PLANNING COMMISSION MEETING STAFF REPORT

NAME OF PROJECT: Mill Canyon Farms

AGENDA ITEM: Concept Plan Review

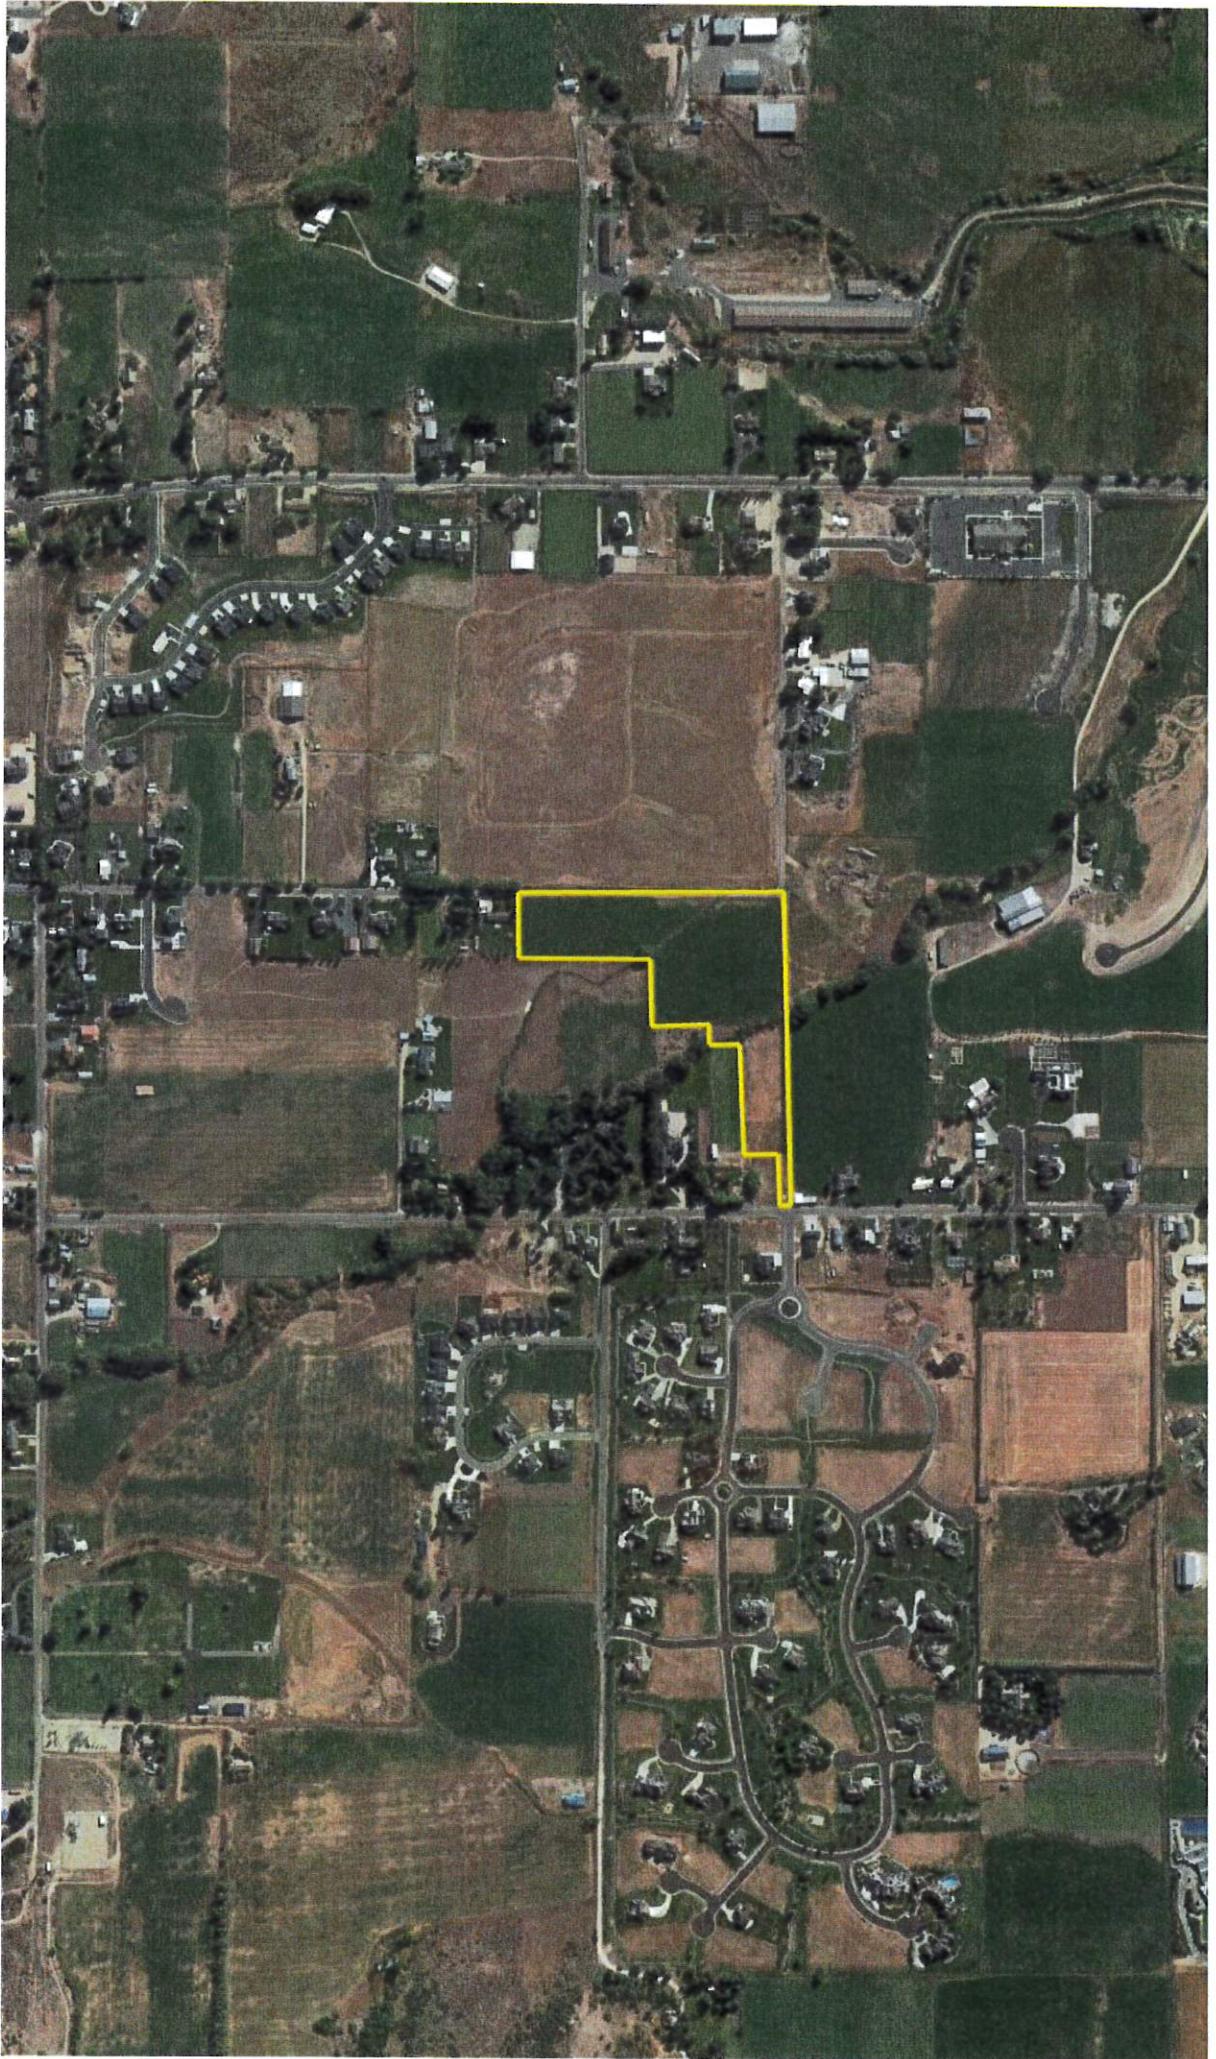
The applicant's proposal must include the dedication of the right-of-way for the future extension of 970 South from 250 West to Stringtown Road, which is identified on the Midway City Road System Master Plan as a local collector with a 60' right-of-way. The applicant will only be dedicating the right-of-way, the road improvements will be made by others.

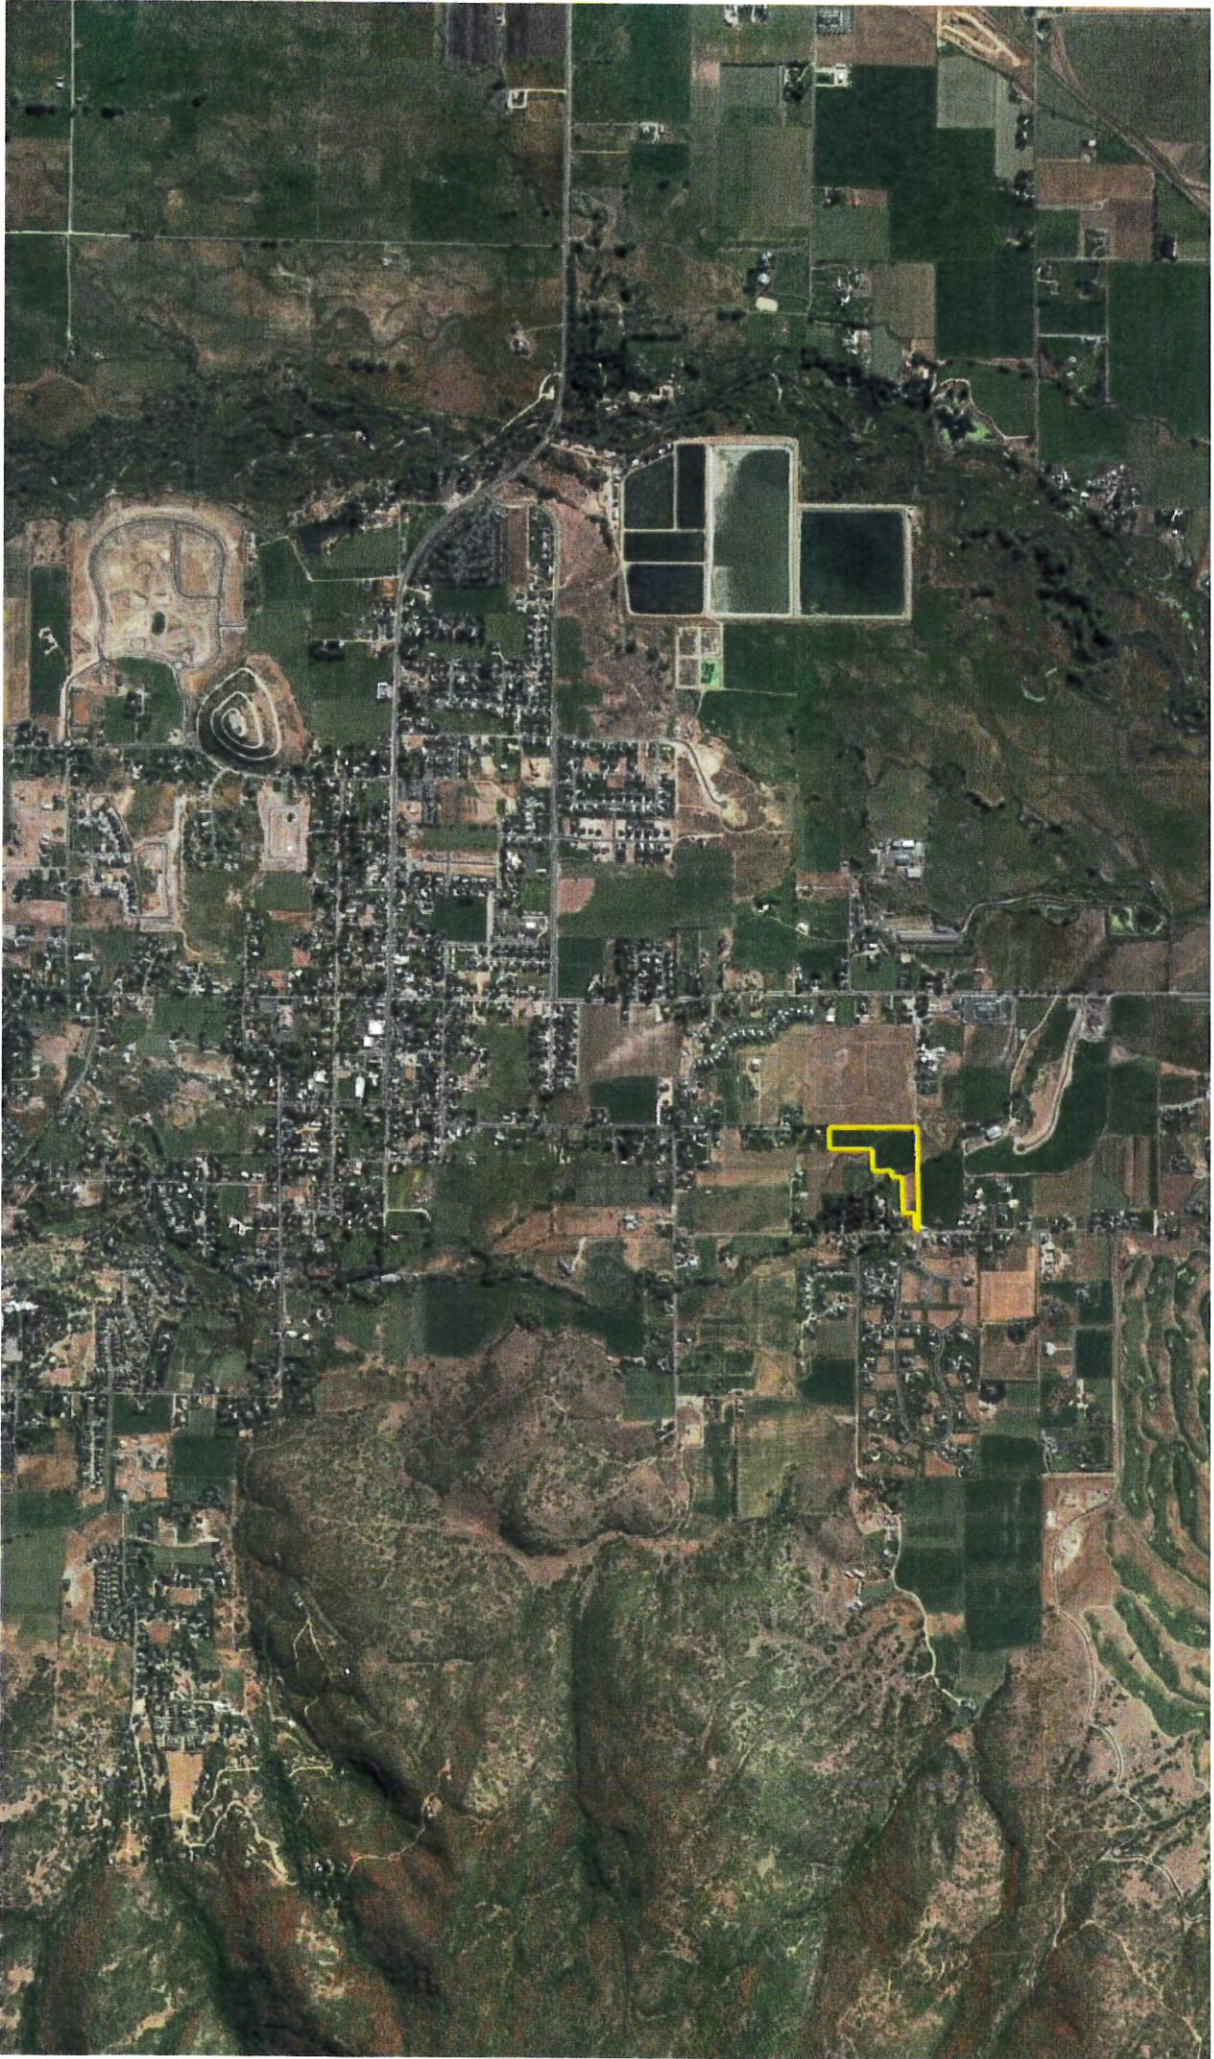
Standard subdivisions greater than 10 acres in size are required to provide a minimum of 15% open space. The applicant will be required to provide a minimum of 1.53-acres of open space. They will need to identify whether the open space is its own parcel or whether it is contained within a building lot. If it is within a building lot, which is allowed if the lot is a minimum of two acres, the 1.53-acres needs to be specifically identified on the plat and they will also need to include a plat note that limits the use as well as excludes the construction of any structures on the open space. Uses on the open space need to be in harmony with the intent of open space as listed in the land use code.

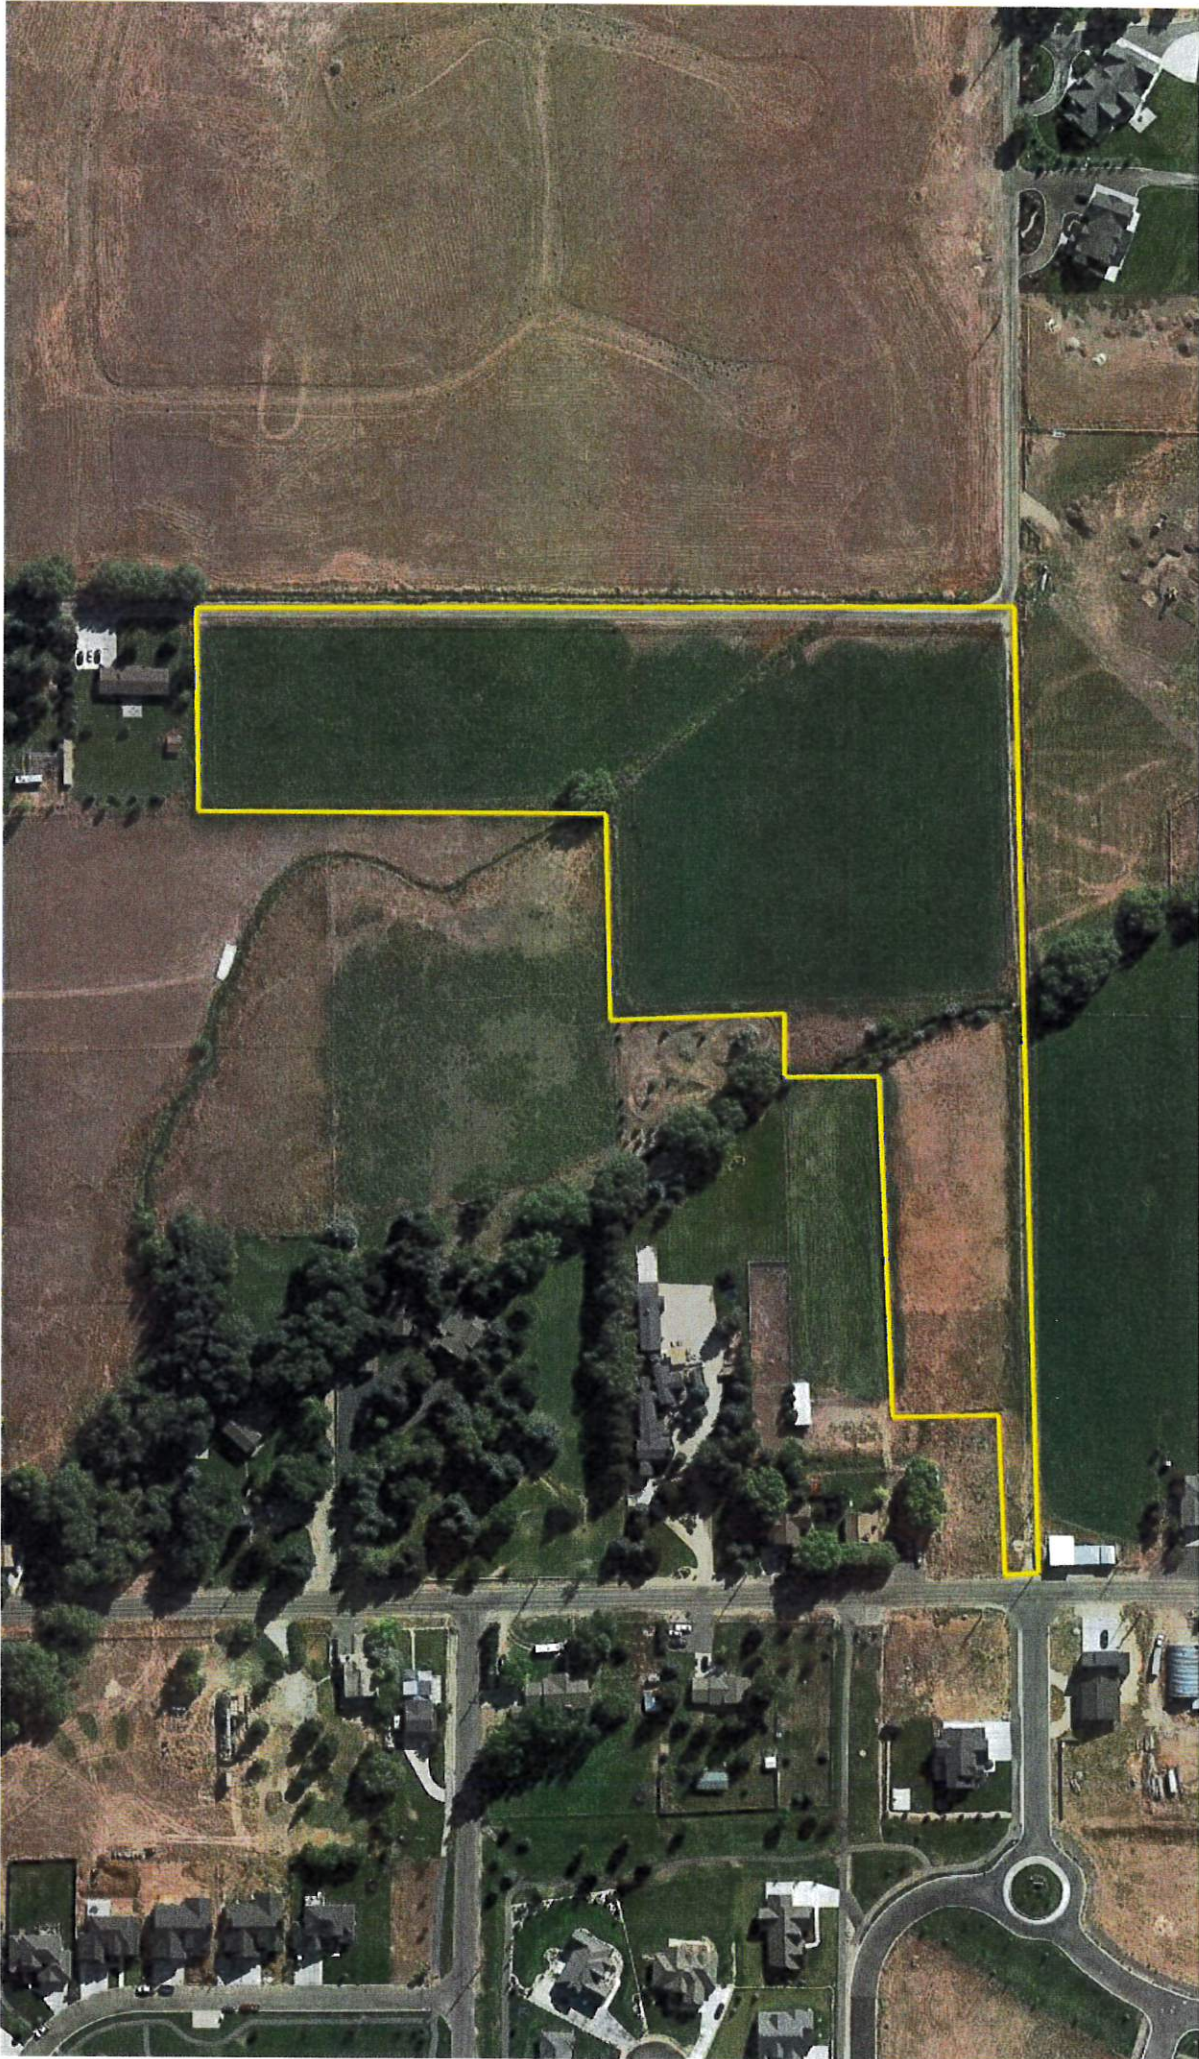
The Midway City Trail System Master Plan shows paved trails crossing the property. The Saddle Creek development is installing the required trail along 250 West. The applicant will need to provide a 15' public trail easement along the right-of-way for the future 970 South as well as a 15' public trail easement along the Snake Creek stream channel.
